Agenda Item # 6

SUB-003247-2025

G5 Parking Subdivision, First Addition

APPLICATION NUMBER 6 DATE March 20, 2025

DETAIL SITE PLAN

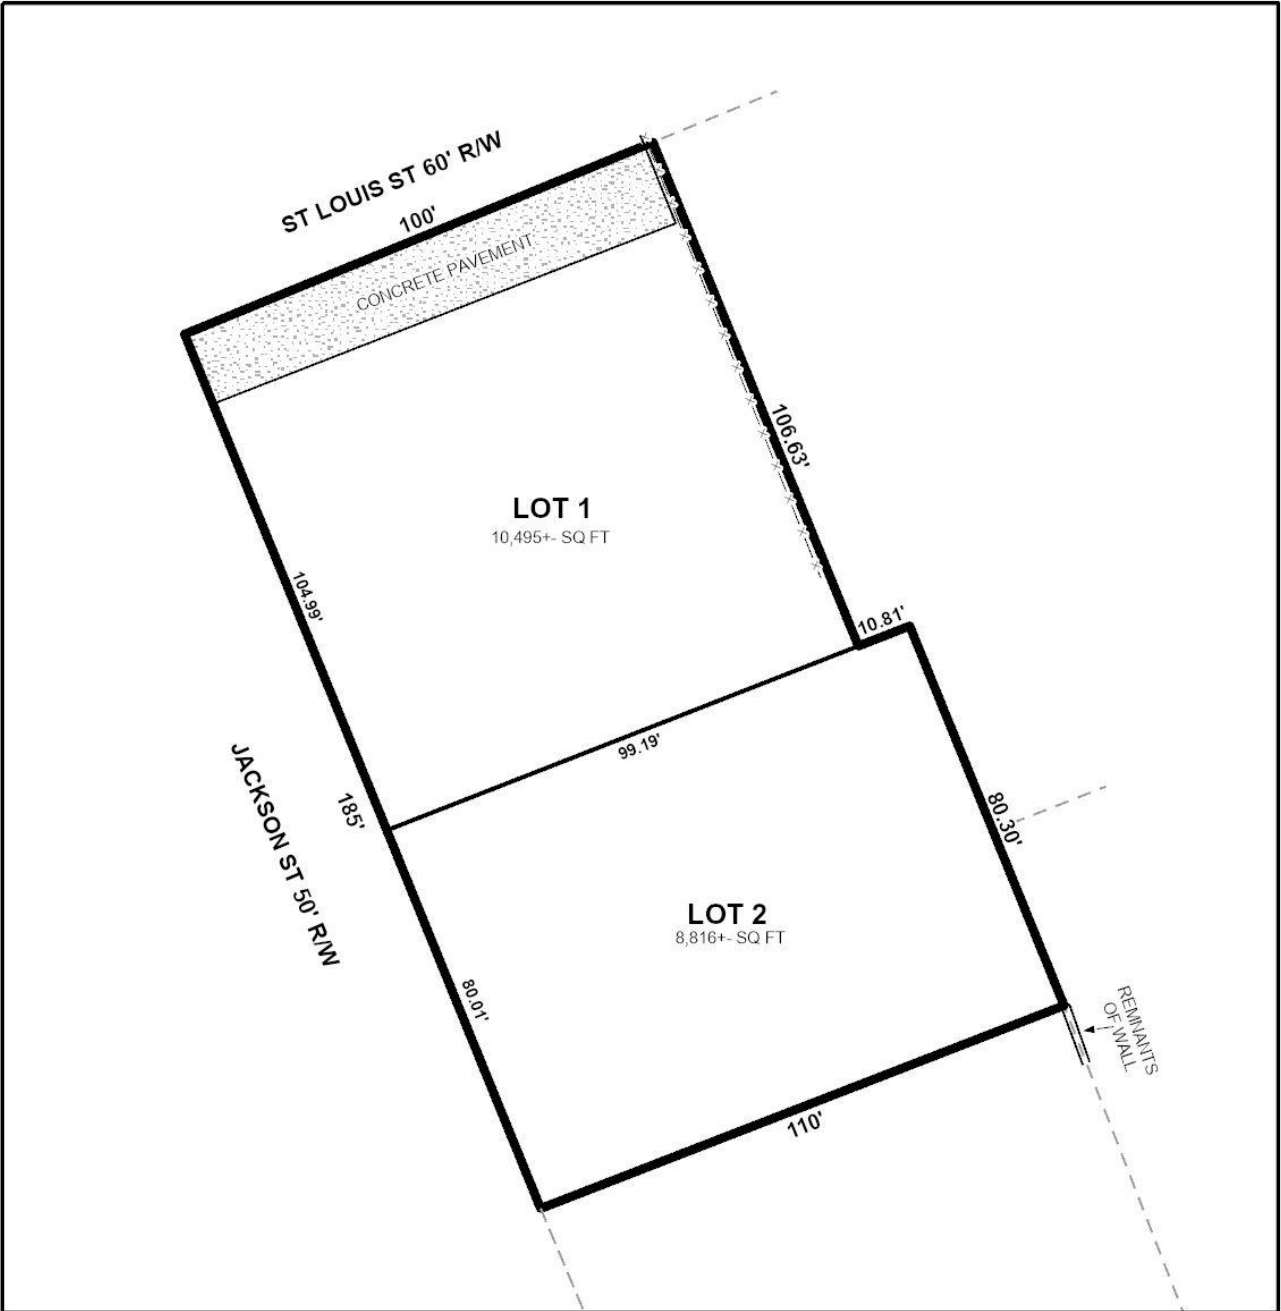
- B. Check and revise the flood zone note. These two (2) lots appear to be located only in the x-shaded zone and not the AE zone.
- C. Show and label the MFFE (Minimum Finished Floor Elevation) on each lot that contains an A, AE, or X (shaded) flood zone designation. BFE = 12.

- D. Revise NOTE #7 to read – “As shown on the 1984 aerial photo LOTS 1 & 2 will share the 3,300 SF historical credit of existing (1984) impervious area towards stormwater detention requirement per Mobile City Code, Chapter 17, Storm Water Management and Flood Control) as follows: LOT 1 – 10,495 SF and LOT 2 – 8,816 SF.

The subject site is currently undeveloped. The DDD requires parking to be accessed from a secondary frontage where available. A note stating this should be placed on the Final Plat, if approved. As the proposed Lot 1 will have frontage along both North Jackson Street and St. Louis Street, a primary frontage must be designated. St. Louis Street is an “A” street in the DDD, thus it is required to be the primary frontage. If approved, a note on the Final Plat should identify St. Louis Street as the primary frontage for Lot 1. Both lots are wide enough to be allowed a curb cut, if approved.

Properties located within a T-5.1 sub-district are allowed a 12-foot maximum setback along street frontages. If approved, the maximum setback line should be depicted on the Final Plat.

The preliminary plat does provide the proposed lot sizes in square feet and acres. If approved, this information should be retained on the Final Plat or a table should be furnished on the Final Plat providing the same information.

1. Retention of the existing right-of-way along all street frontages;
2. Depiction of the 12-foot maximum setback along all street frontages;
3. Retention of the lot sizes in both square feet and acres, or the furnishing of a table on the Final Plat providing the same information;
4. Placement of a note identifying St. Louis Street as the primary frontage for Lot 1;
5. Placement of a note stating that parking is to be accessed from a secondary frontage where available;
6. Compliance with all Engineering comments noted in this staff report;
